**The Peelle Company**

## **TECHNICAL BULLETIN**

### **SPECIAL INSTALLATION INSTRUCTION**

**SUBJECT:** REPLACEMENT DOOR MOTOR

MOTOR SPACER SHIM. MAY NOT BE EXACTLY AS SHOWN.

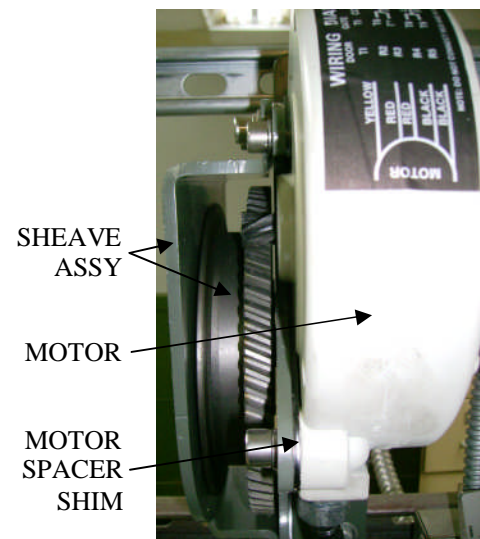
**DESCRIPTION:** PEELLE HAS DISCOVERED THAT WHEN REPLACING A 056910M DOOR MOTOR, THE BOSS ON THE MOTOR FACE COULD INTERFERE WITH THE EXISTING GEAR ON THE SHEAVE ASSEMBLY.

**1. HOLD NEW MOTOR IN PLACE AND CHECK GAP**  
IF LESS THAN 1/16" GAP, USE MOTOR SPACER SHIM. IF GAP IS 1/16" OR GREATER, INSTALL MOTOR WITHOUT MOTOR SPACER SHIM.

**2. PLACE MOTOR SPACER SHIM ON SHEAVE ASSEMBLY**  
USE 3/8" x 3/4" SOCKET HEAD CAP SCREW AND 3/8" WHIZ NUT TO HOLD MOTOR SPACER SHIM IN PLACE. USE BOTTOM MOUNTING HOLE.

**3. REPLACEMENT MOTOR MOUNTED ON SHEAVE ASSEMBLY WITH MOTOR SPACER SHIM**

**ACTION:** BEFORE INSTALLING A NEW 056910M DOOR MOTOR, PLACE THE MOTOR IN POSITION AND CHECK THE GAP BETWEEN THE MOTOR BOSS AND THE SHEAVE GEAR. IF THE BOSS IS LESS THAN 1/16" AWAY FROM THE GEAR, USE THE MOTOR SPACER SHIM INCLUDED WITH THE REPLACEMENT MOTOR.
